CLIENT COMMENTS AND NOTES - 04/05/2023

client: Mr & Mrs Copnall  
project: Westwick Lock House, Harrogate

drawing: Proposed Extension & Alterations  
Finishes Layout

job no: 1103 dwg no: 114 rev:

GROUND FLOOR PLAN FINISHES LAYOUT

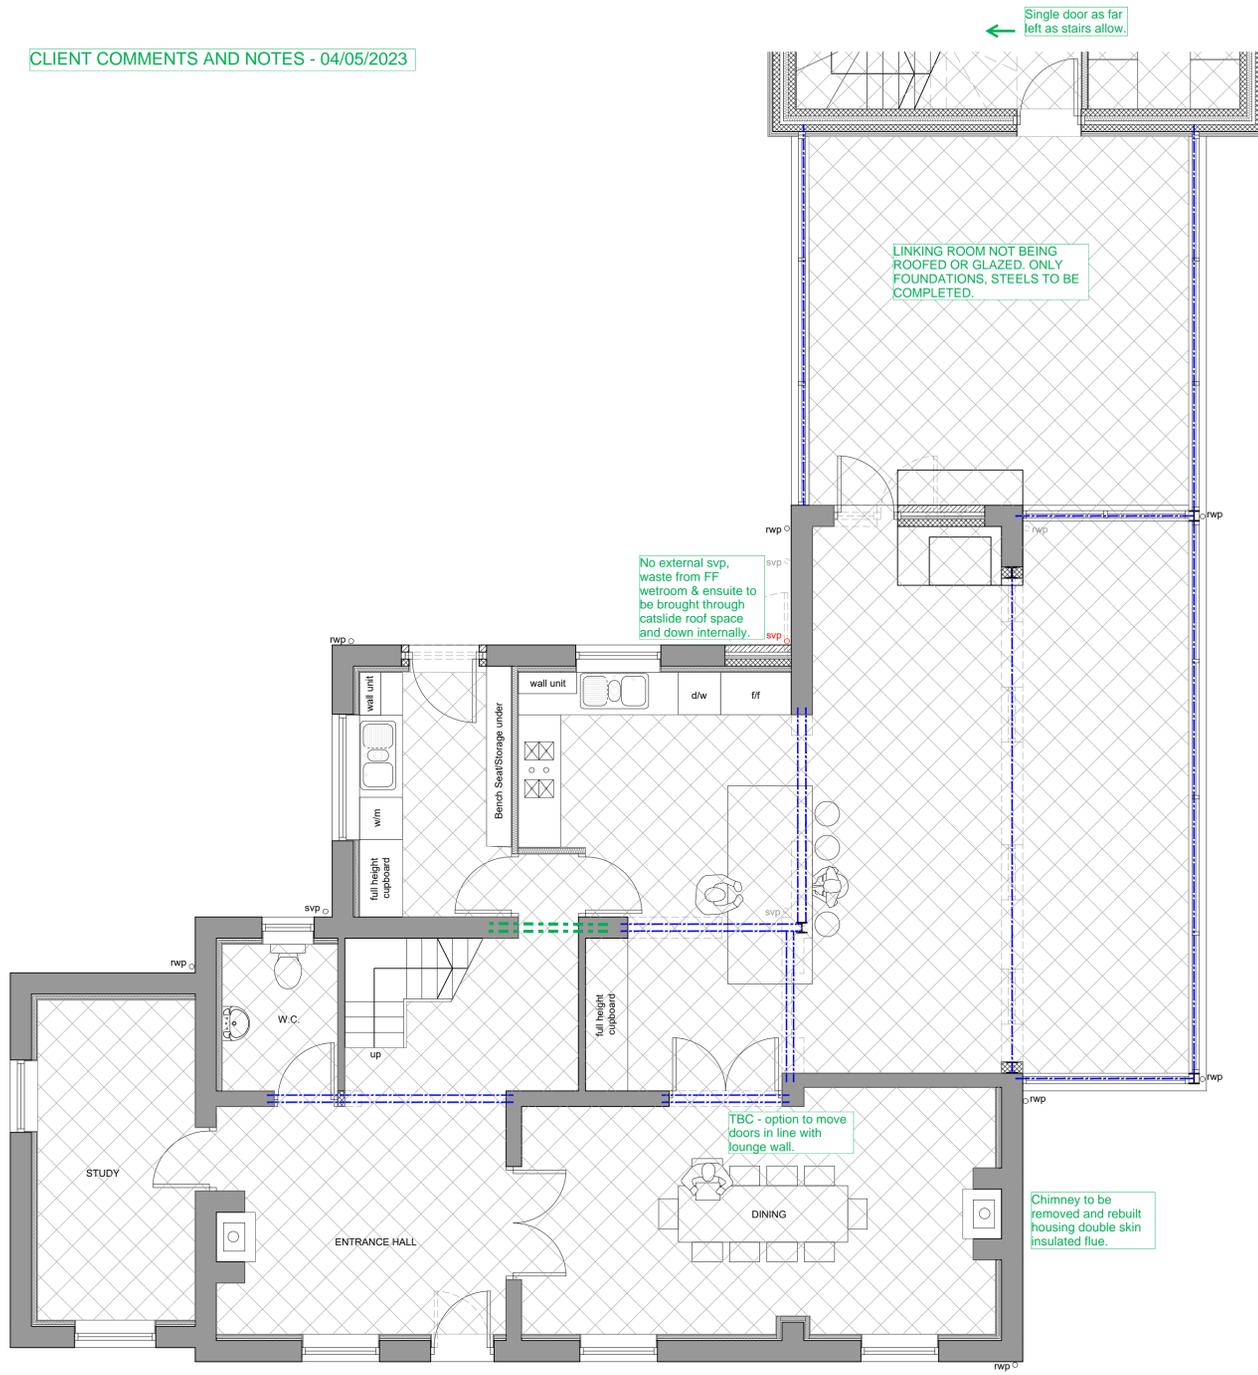
**NEW INTERNAL DOORS:**  
All doors to be solid and All doors to be confirmed with client prior to order and installation.  
To be finished on site using a clear matt varnish.  
Do not fix until all wet trades is finished and dried out.  
Fazing Centres for Timber frames:  
When not predrilled position fixings 150mm from each end of jamb, adjacent to each hanging point and at 600mm centres.  
ALLOW FOR NEW PENCIL PROFILED PLAIN SKIRTINGS (CIRCA 75MM HIGH) AND MATCHING ARCHITRAVES THROUGHOUT ALL TO BE CONFIRMED BY CLIENT, PRIOR TO ORDER.

- Porcelain tiles to be compatible with underfloor heating
- New engineered oak floor 15mm thick (with 4mm wear layer) Random width boards, 140mm, 180mm & 220mm wide T&G boards, with micro bevel on long edges only.  
Client supplied (stored at NY Timber, Northallerton).
- TBC with client.  
Option 1: C30 Cemfloor @ 60mm, supply & install by Ward Flooring, Burton on Trent - contact Ian Hebblewhite.  
Option 2: But jointed, large format stone tiles.  
Ensure level threshold to external doors, seamless finish between inside and outside flush.
- Reinforced Concrete Slab in accordance with structural engineers details and specifications)  
with seamless Resin Methyl Methacrylate resin coating - colour TBC by client (Client to confirm requirement for insulated floating floor for ground floor garage conversion)

Allow for full height wall tiling to bathroom client to provide sanitaryware and tiles.  
Allow for fixing.

FLOORING TYPES TO BE CONFIRMED BY CLIENT PRIOR TO INSTALLATION.

MUST BE COMPATIBLE WITH UNDERFLOOR HEATING.

ENSURE ALL FINISHES ARE SUITABLE FOR UNDERFLOOR HEATING & ENSURE MOVEMENTS JOINTS ARE INCLUDED IN FLOOR IF HEATING IS NOT TO EXTEND THROUGH ENTIRE DINING AND LIVING SPACE  
CHECK WITH ARCHITECT PRIOR TO UNDERTAKING THE UNDERFLOOR HEATING AND PRIOR TO ORDERING FLOOR FINISHES.
